**Meeting of the Central Valley Flood Protection Board
June 24, 2011**

Staff Report – Informational Briefing

**California Department of Parks and Recreation
Singh Unit Restoration Project, Butte County**

Figure 1: Model Location Map showing project area

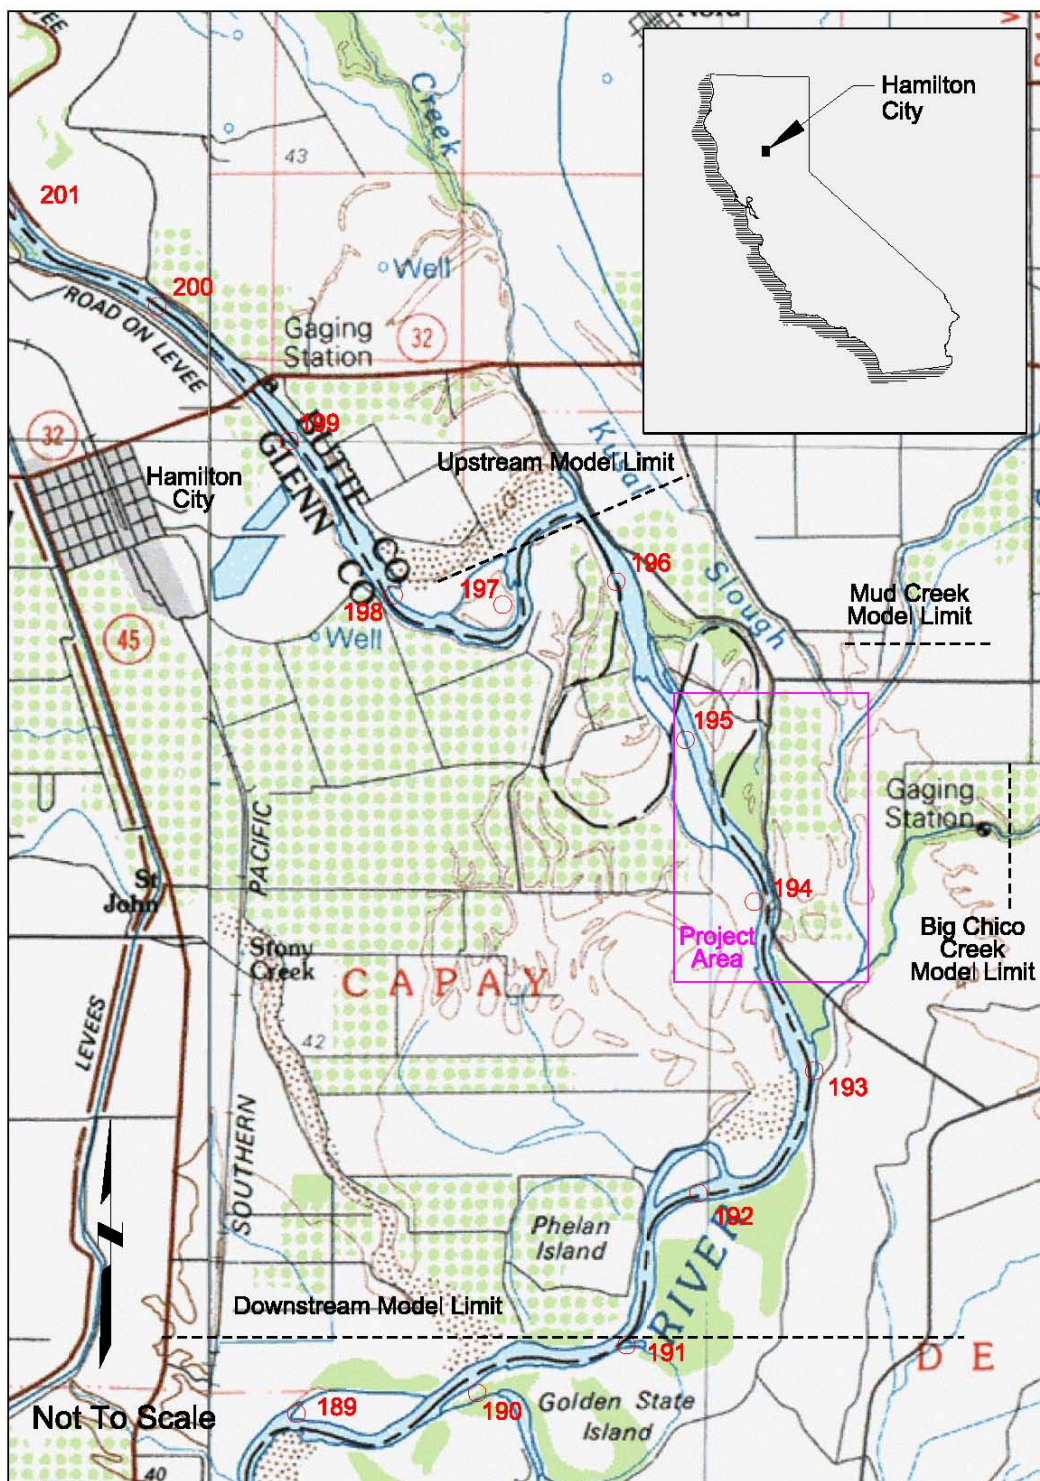
The 2D modeling tool used was the RMA-2D program, maintained and distributed by the US Army Corps of Engineers (USACE), and modified by Ayres Associates. For model running efficiency, the boundary limits for this proposed project's model were constrained to river mile (RM) 191 to RM 196.5, as shown in Figure 1, Attachment D.

Figure 2: Water Surface Elevation Differential – Restoration to Existing

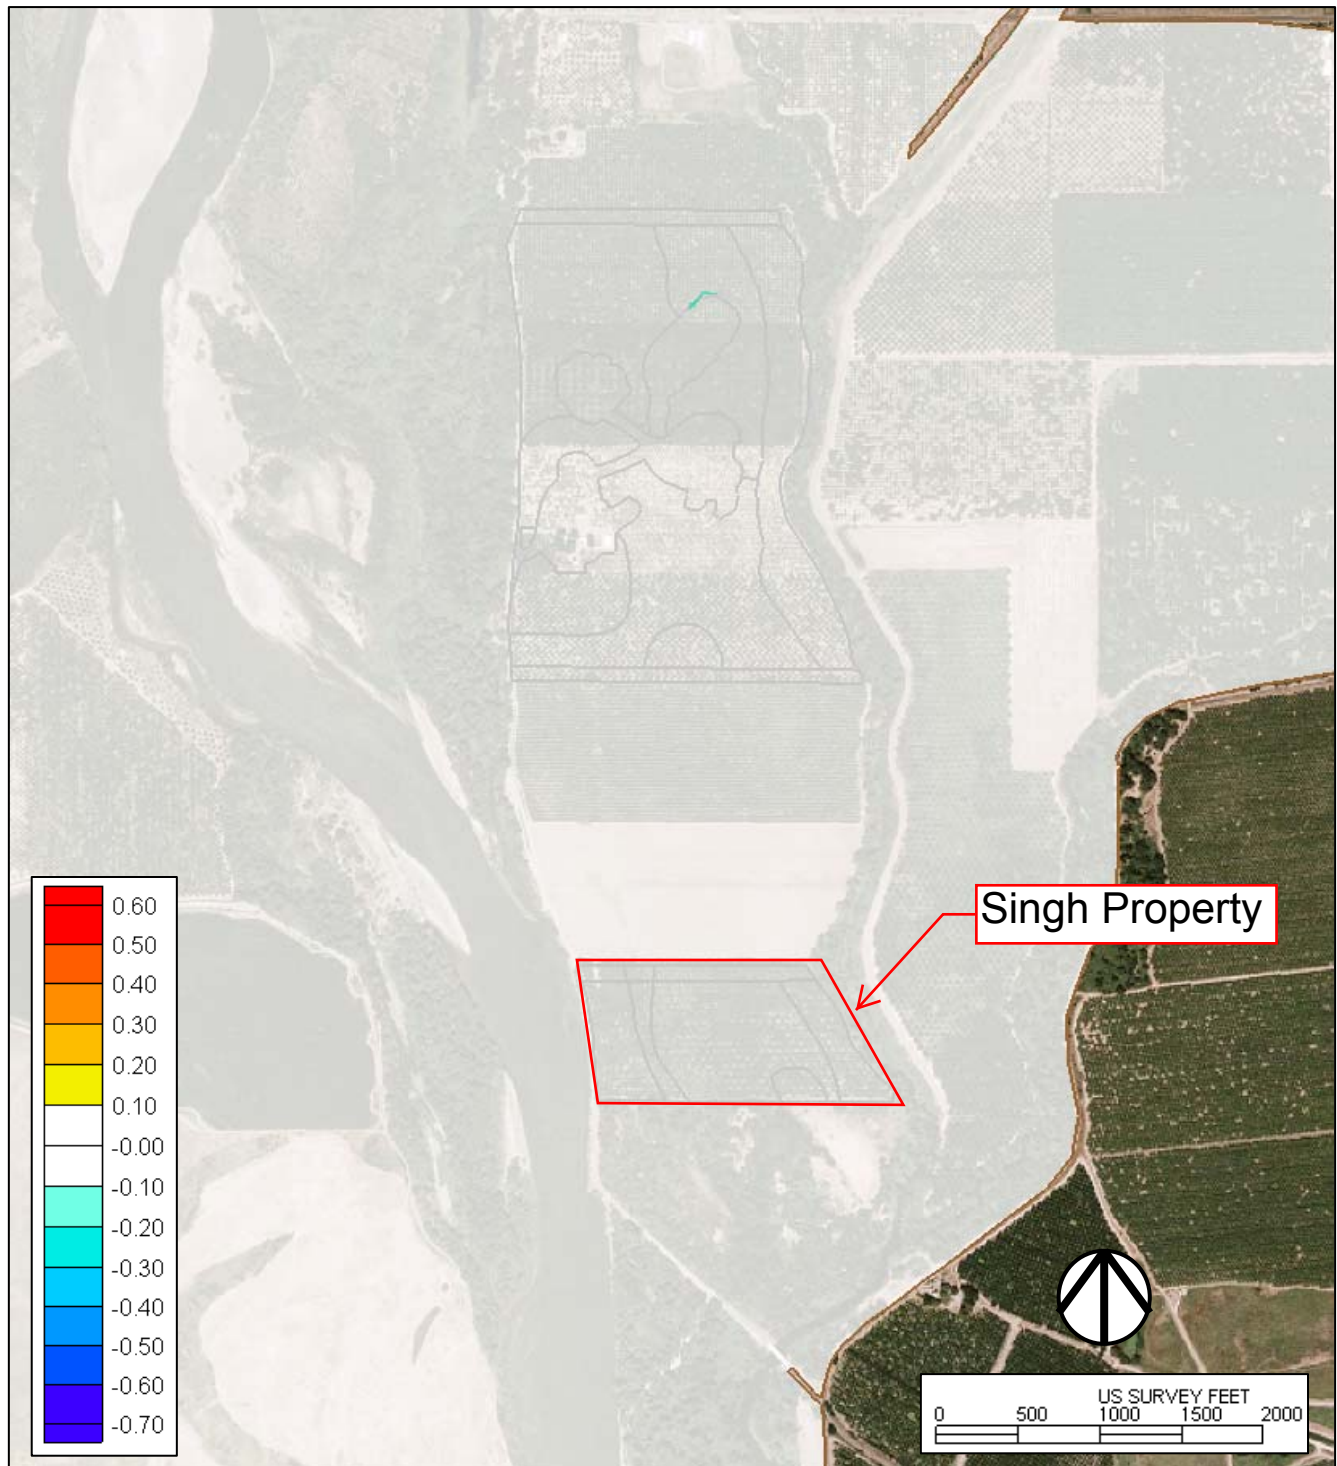
- The water surface elevation (WSE) differential between the existing and proposed project conditions is not apparent because the model does not use the 1968 floodway land use for the adjacent downstream parcel as the baseline condition for the floodway (see Figure 2, Attachment D).

Figure 3: Restoration Conditions Velocity

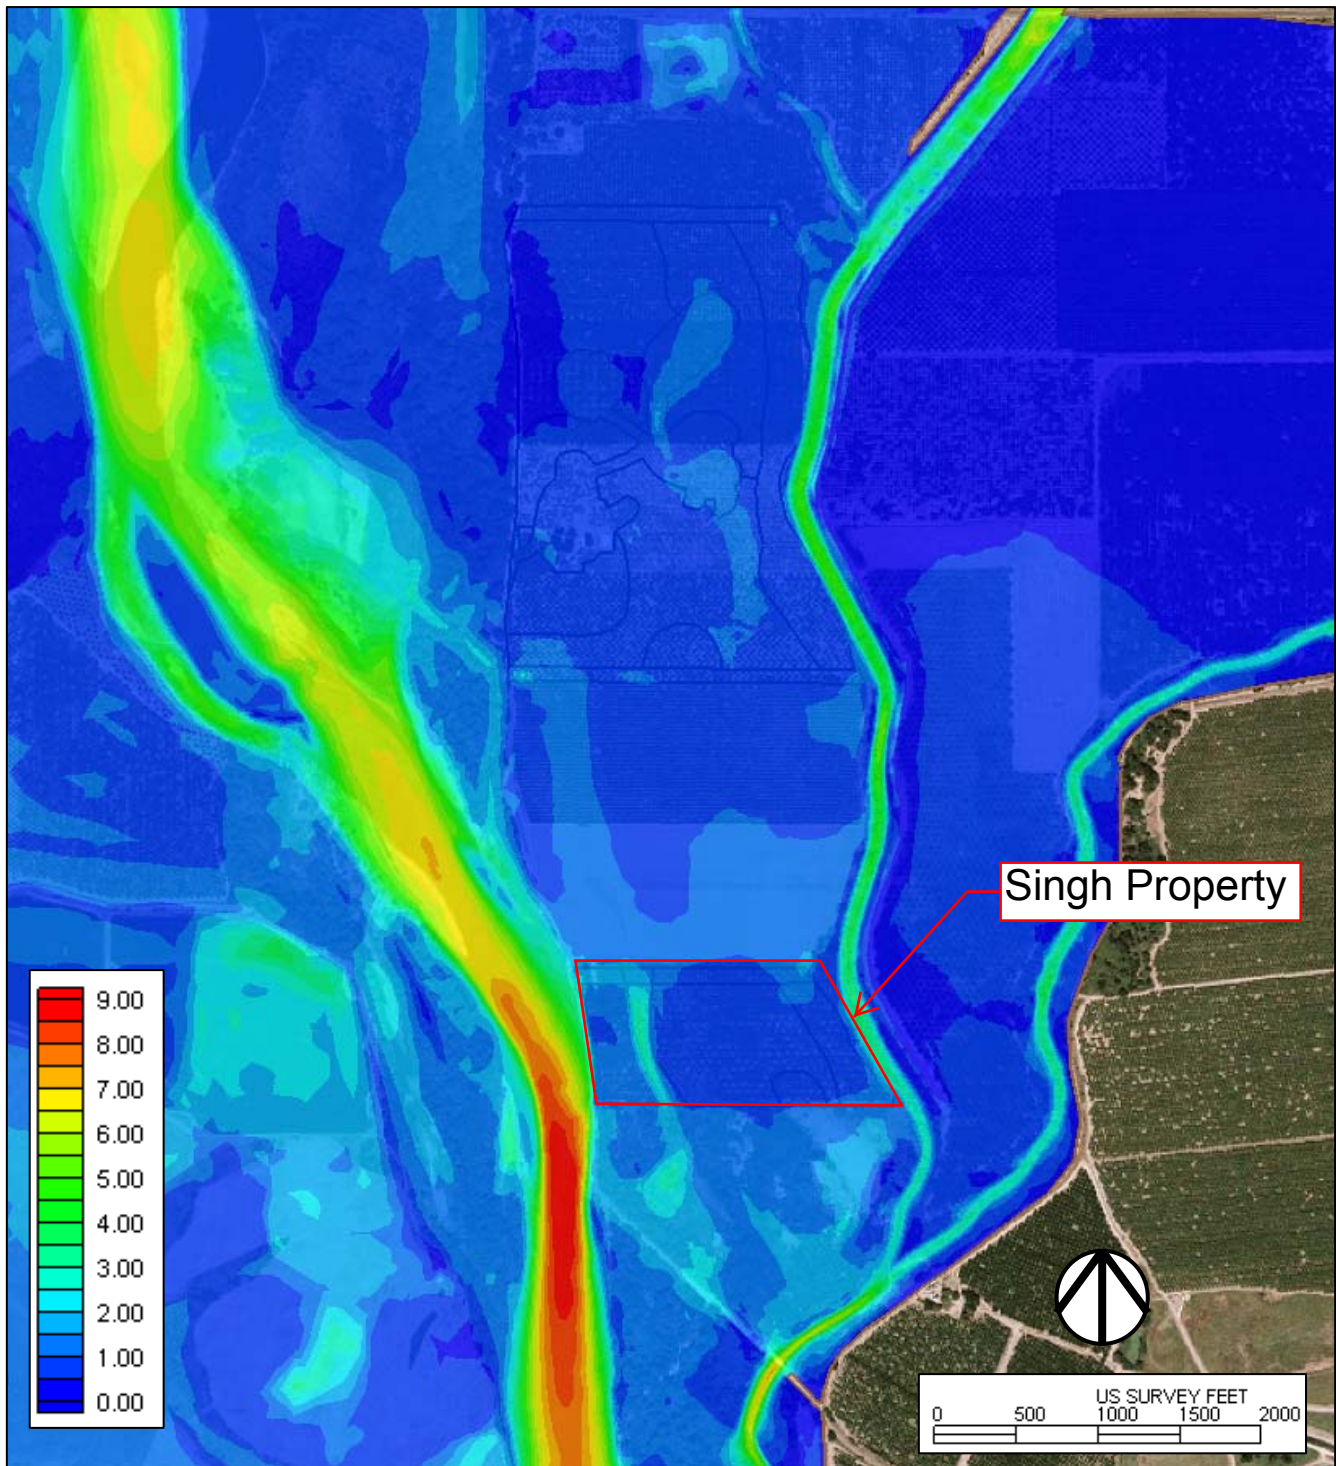
- Water velocity in the proposed flow-through meadow increases 2.0 feet/sec (ft/s), however given a low 1 ft/s existing velocity condition, and planned vegetation, the resulting velocity of 3.0 ft/s will not create harmful effects and is not considered erosive for grass cover (see Figure 3, Attachment D).

Figure 4: Velocity Differential – Restoration to Existing

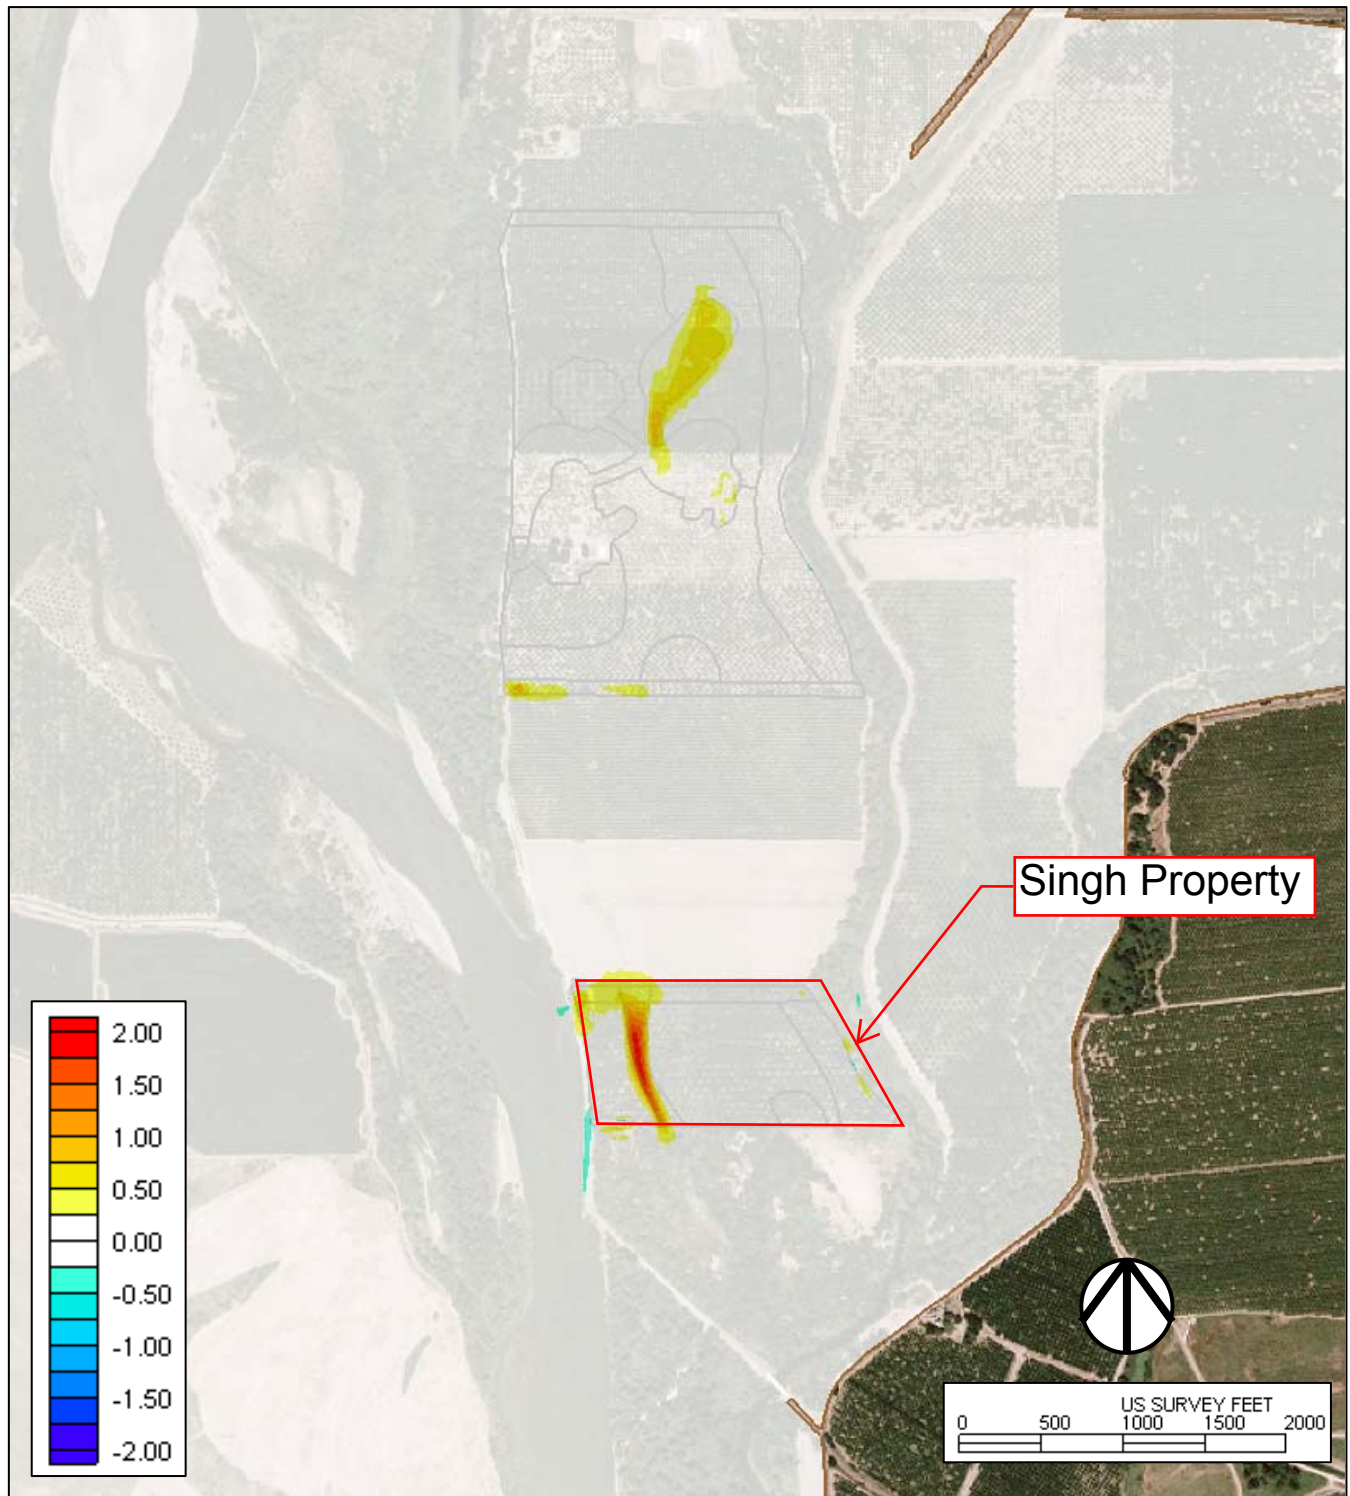
- The proposed condition model shows a slight increase in water velocities in the grass buffer and berm removal areas of 0.5 ft/s and 0.7 ft/s respectively (see Figure 4, Attachment D). The berm removal also slightly reduces velocity on the east bank of the Sacramento River next to the project site.
